Nature of Project:
Construct addition; relocate existing
deck; remove fencing; alter driveway

APPLICATION FOR A CERTIFICATE OF APPROPRIATENESS – STAFF REPORT

COA-0141-2019 2310 BEDFORD AVENUE

2208 Bedford Avenue - front facade 45' wide; house to lot ratio - 75%

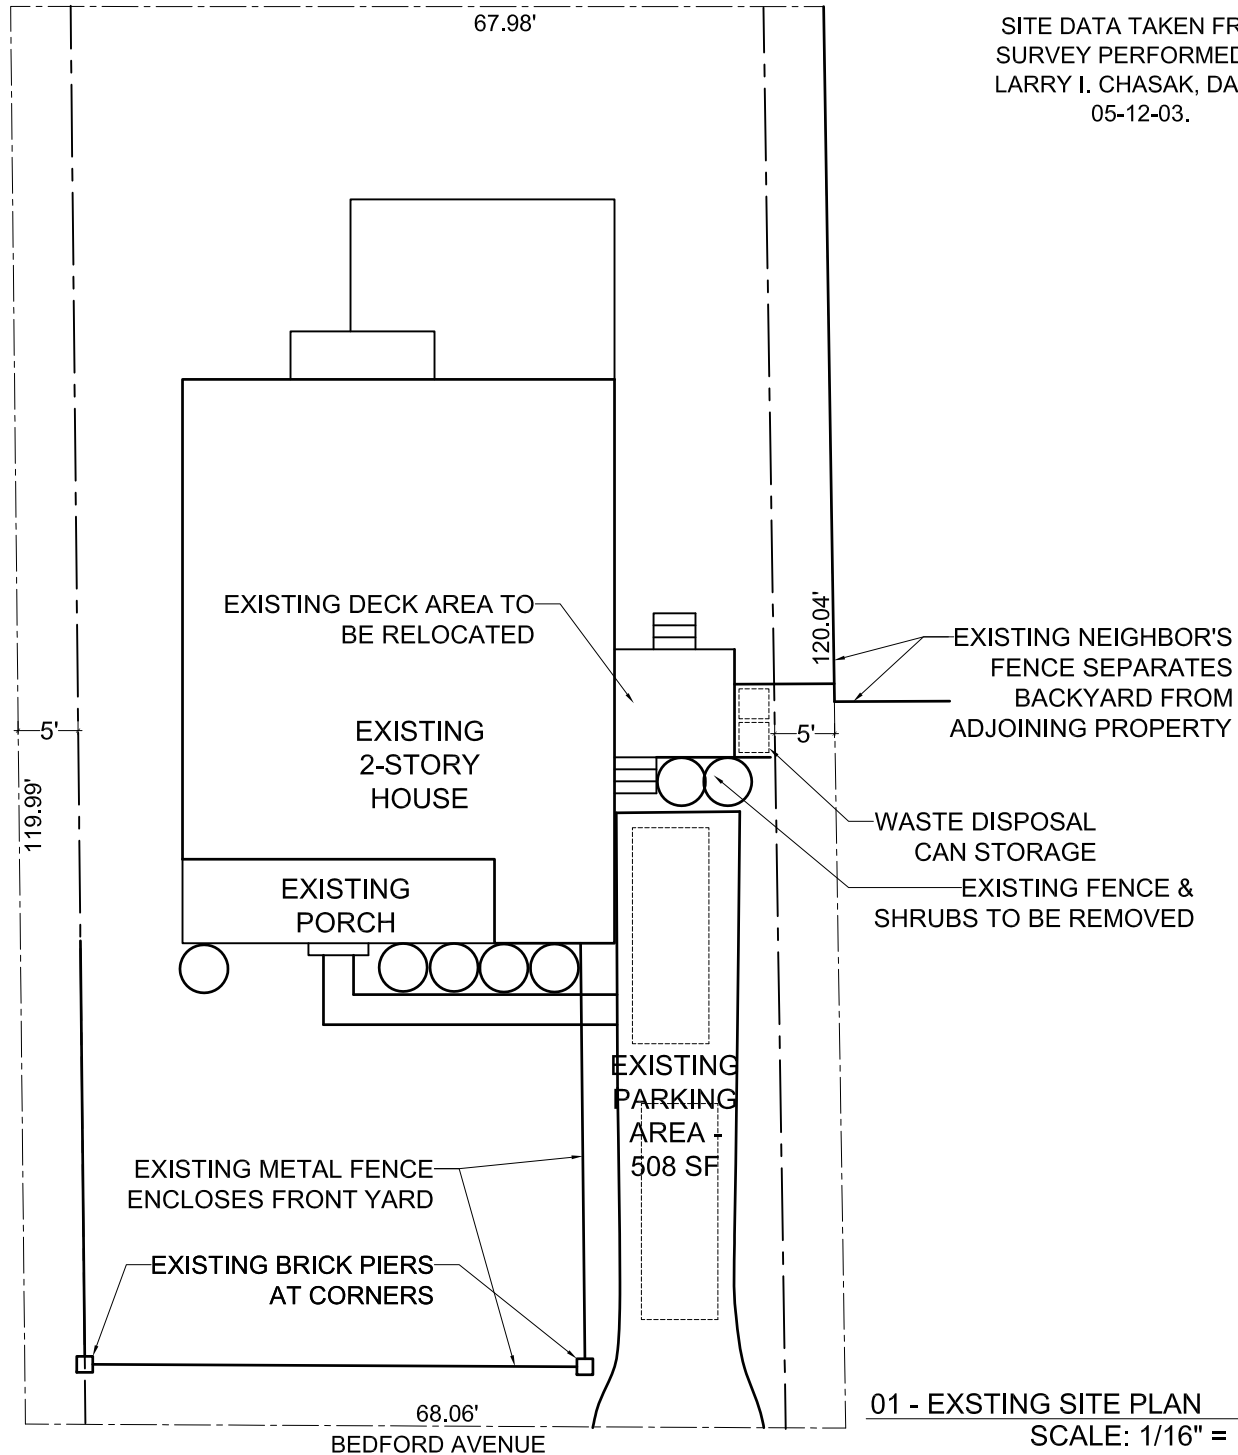
- 13* Photographs of other properties in Oberlin Village with a house-to-lot-width ratio in the 70% range were provided:
 - a. 2208 Bedford Avenue - 75% house-to-lot-width ratio.

- b. 710 Chamberlain Street - 72% house-to-lot-width ratio.
- c. 2312 Bedford Avenue – 75% house-to-lot-width ratio. This contributing house is immediately to the west.
- d. 2208 Roberts Street – 71% house-to-lot-width ratio.
- e. 2211 Roberts Street – 72% house-to-lot-width ratio.
- f. 2210 Bedford Avenue – 72% house-to-lot-width ratio. This non-contributing property has a similar one-bay addition on the side of the property.

PROPOSED
SITE PLAN
A100

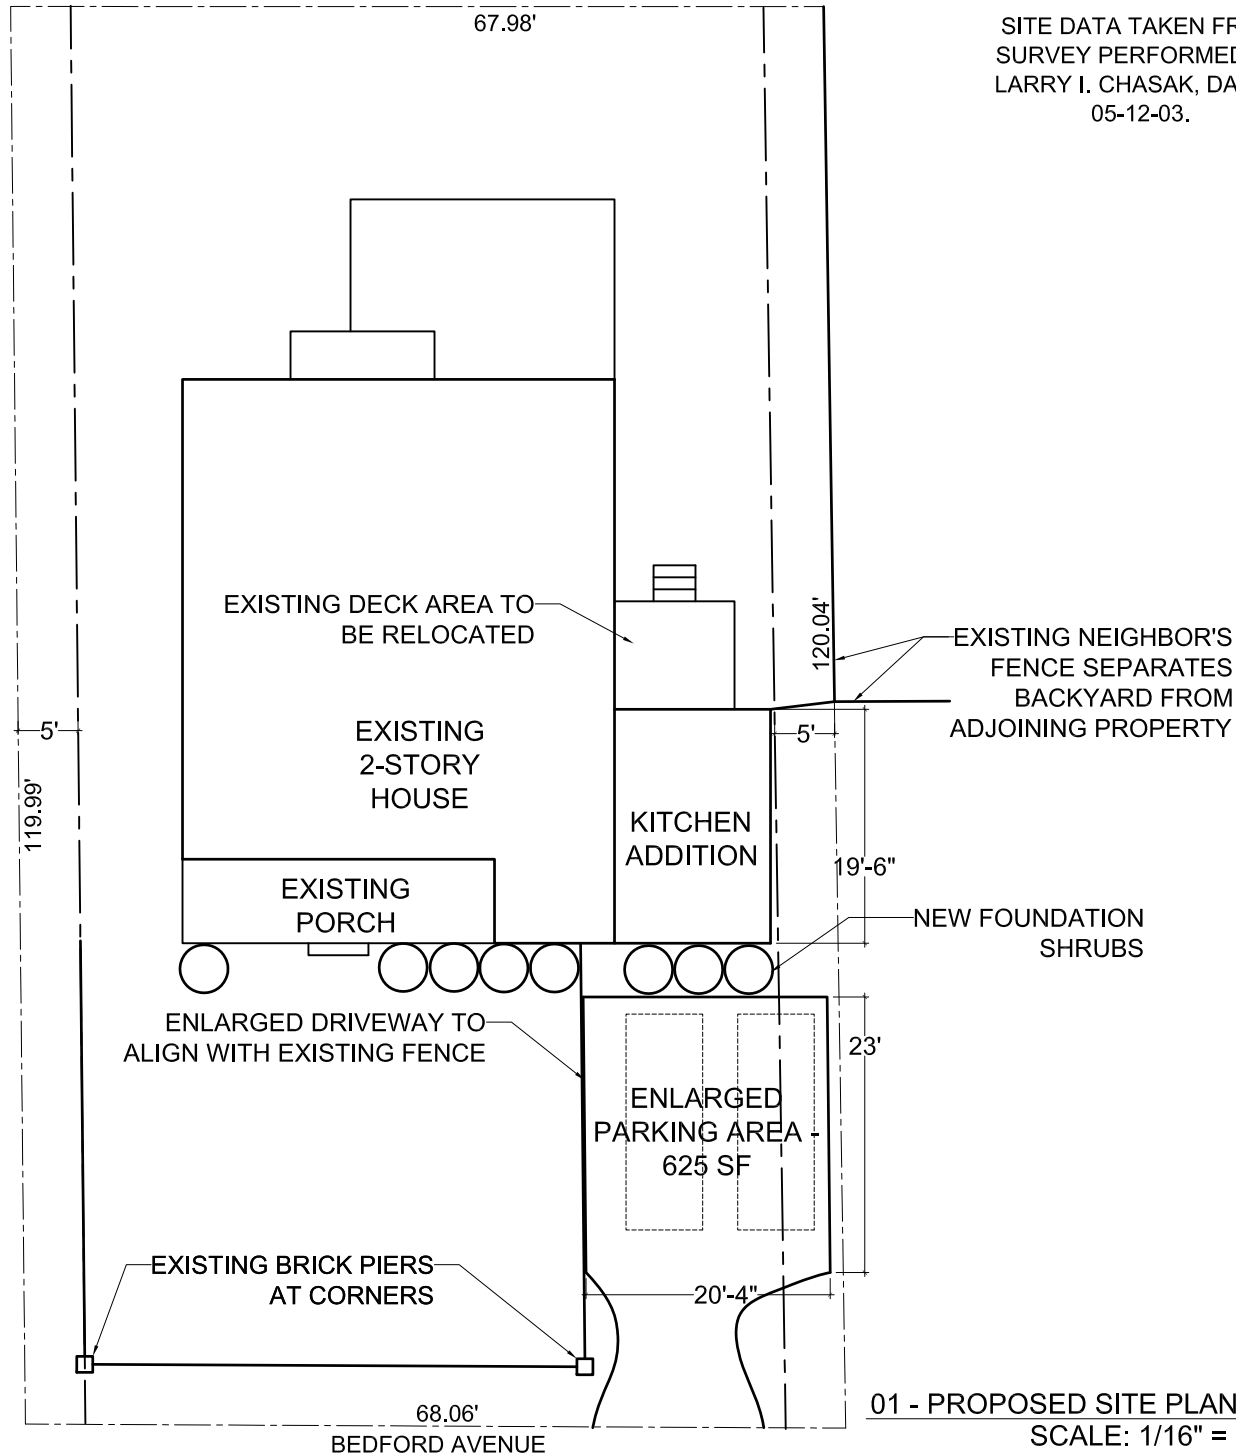
- 4* The application proposes the construction of a 254 SF one-story addition on the east side of the house.
- 5* The addition extends the wall plane of the front wall of the house. A reveal at the existing corner board is proposed to provide differentiation from the existing house. The depth of the reveal was not provided.

B. Altering a driveway is not incongruous in concept according to *Guidelines* section 1.5.5, 1.5.7; however, installing a double-width driveway **may be** incongruous according to *Guidelines* section 1.5.5, 1.5.7, 1.5.10; and the following suggested facts:

20* The existing driveway is proposed to be doubled in width in front of the proposed addition. Materials are proposed to match existing.

21* A two-car width concrete driveway is atypical for properties in residential historic districts.

22* The Committee has previously approved double-width driveways where the second space is not concrete or paved.

1. That the windows not be vinyl.
2. That the siding be installed smooth side out.
3. That the driveway expansion not be concrete or paved.
4. That details and specifications for the following be provided to and approved by staff prior to issuance of the COA blue placard:
 - a. Manufacturer's specifications for windows, showing both section and elevation views, and material descriptions.
 - b. A plan locating trees with critical root zones in the area of construction and a tree protection plan, if necessary.

PROPOSED
PLAN
A101

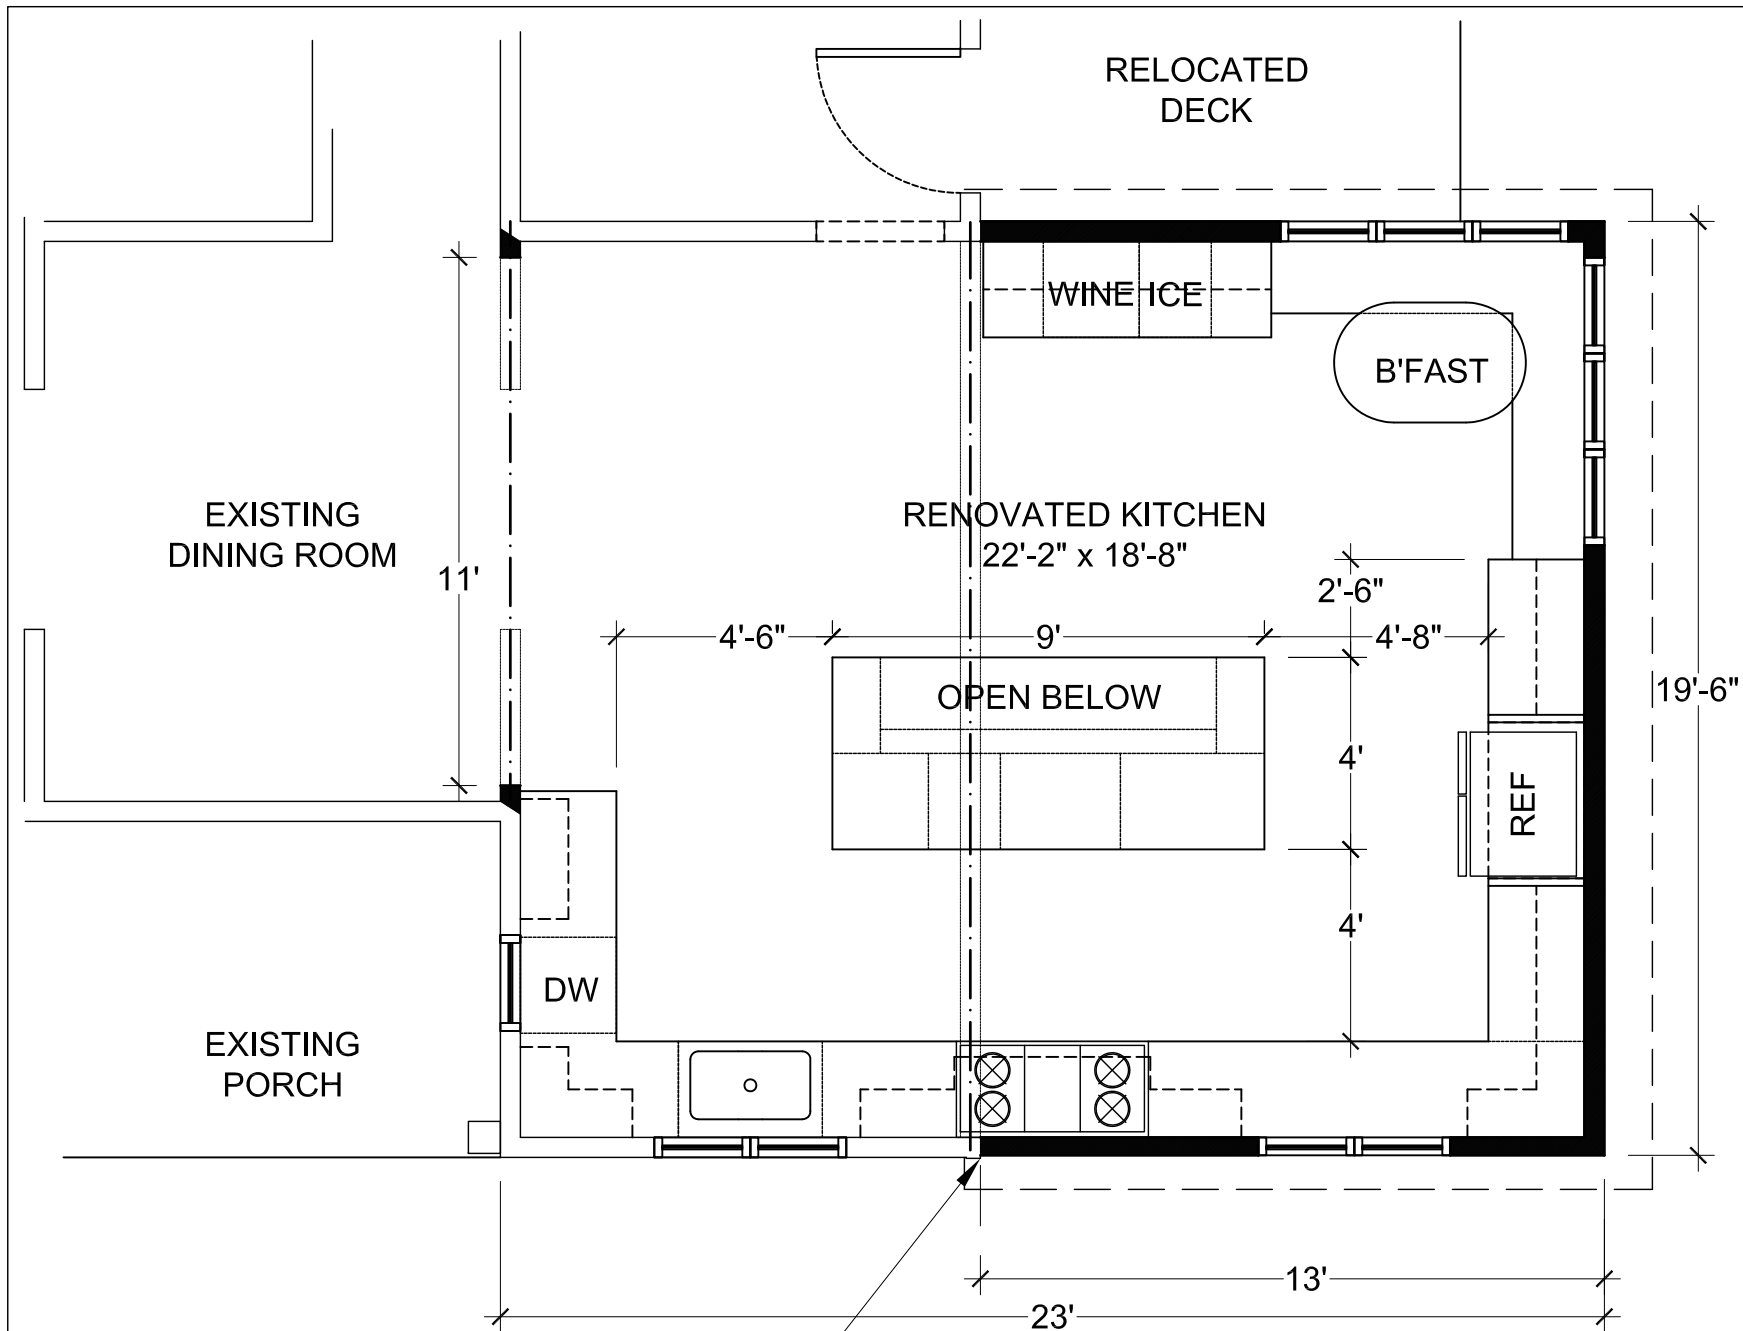
15* Windows are proposed to match existing. The existing windows are vinyl. The Committee has not found that vinyl windows are congruous to the character of any of the historic districts in any situation. Wood or aluminum-clad windows are typically approved.
